GFA AIRWORTHINESS DIRECTIVE

TYPE AFFECTED: H-201 STD LIBELLE, H-201B STD LIBELLE,
H-202 SD LIBELLE, H301 LIBELLE, H-301B LIBELLE.
(German Type Cert No 251.)

SUBJECT: Replacement of Rudder Gimbal Drive, rear actuator arm.

Technical Note
No. 301-39
No. 201-35

301-45-13

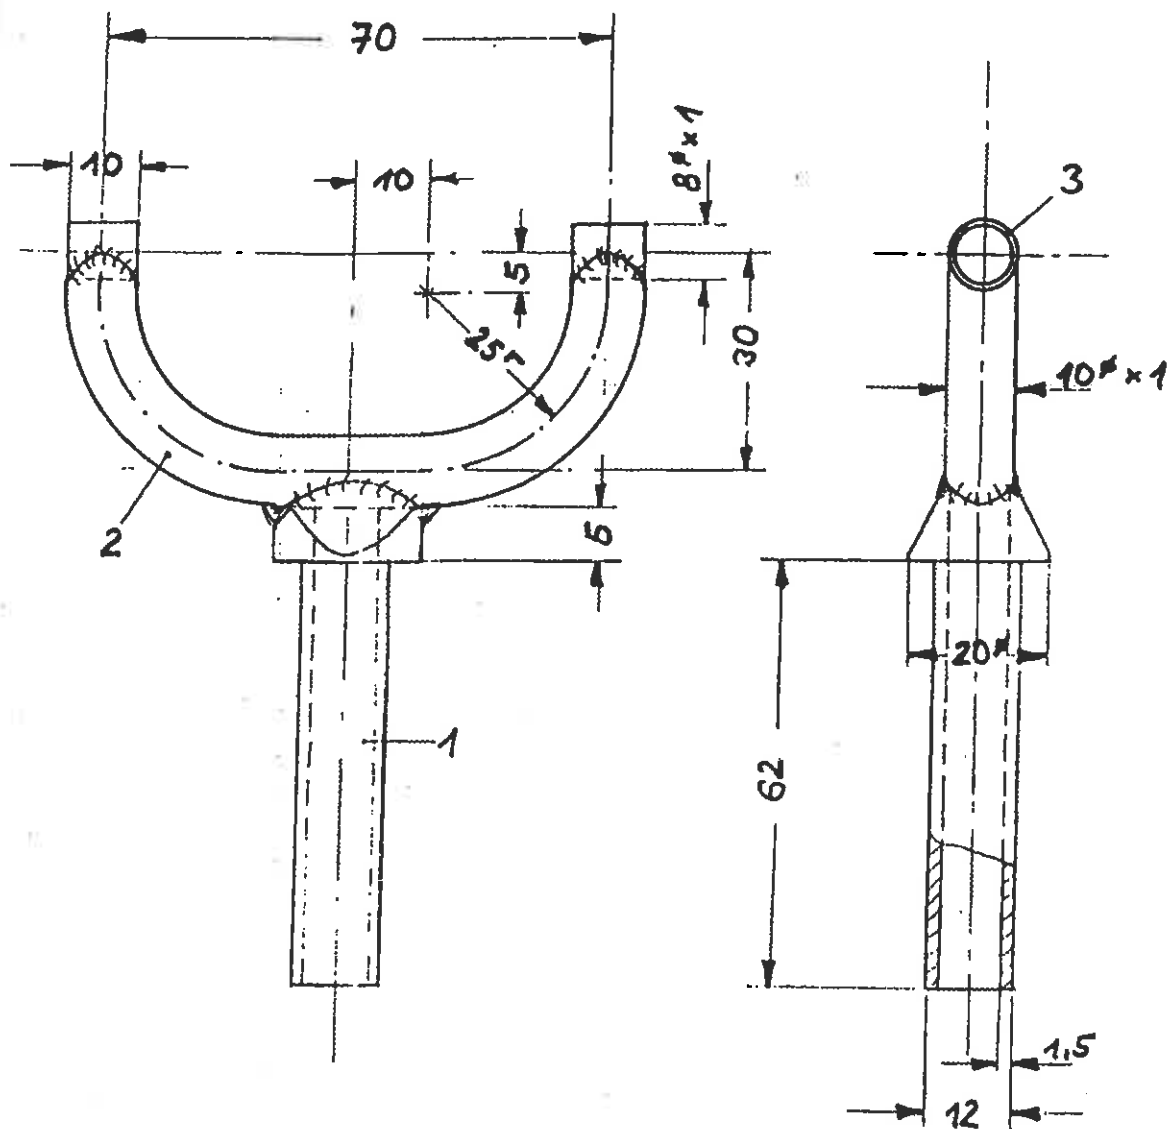
ACTION REQUIRED: In accordance with the above Technical Note replace the actuator arm type 301-45-10 with the improved version type 301-45-13.

Only genuine parts made in accordance with drawing No. 301-45-13 must be used.
